NUREG/CR-1925
SAND81-0242

Diablo Canyon Nuclear Power Station Unit 1 Auxiliary Feedwater System Reliability Study Evaluation

Sandia National Laboratories

The purpose of this report is to present the results of the review of the Reliability Analysis of the Diablo Canyon Auxiliary Feedwater System. The analysis was prepared for Pacific Gas and Electric Company, the licensee for Diablo Canyon, by Pickard, Lowe and Garrick, Inc.

FIGURE 2. RELIABILITY CHARACTERIZATIONS FOR APWS DESIGNS IN PLANTS USING THE WESTINGHOUSE NSSS

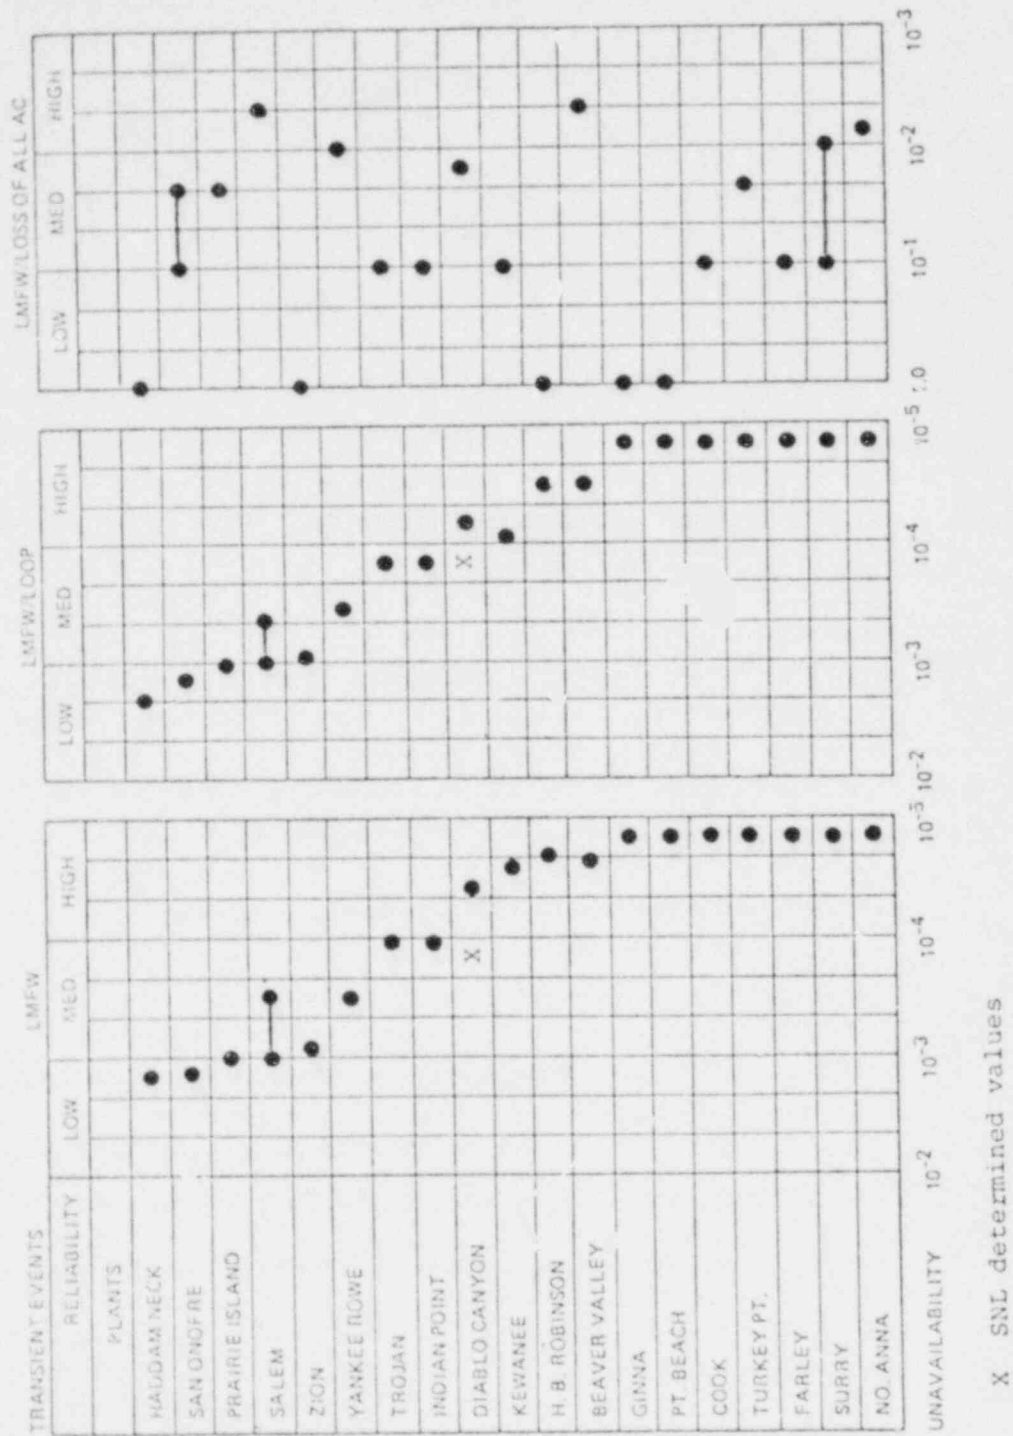
PG&E lists the top events together with their rank order and unavailability for each of the three cases. These are shown in Tables 2, 3, and 4. The sum includes all events or cutsets considered. The sum is plotted on Figure 2 to show how Diablo Canyon compares with operating units as reported by NUREG-0611.

failure in the event of no NPSH has not been established. The operator action should not be considered and the unavailability increased to 1×10^{-4} , the value assigned to the CST outlet valve 1-671 being closed. This value is combined with the unavailability of the other cutsets of lesser rank and plotted on Figure 2. All other values seem appropriate.

The final assessment made by PG&E places Diablo Canyon at the high end of the range of reliability reported in NUREG-0611 for operating Westinghouse plants. Sandia is not in agreement with this assessment for Case 1 and 2 because of questionable recovery factors used to lower the failure assessment of critical basic events. Sandia concludes that for Case 1 and 2 the reliability should be in the medium range.
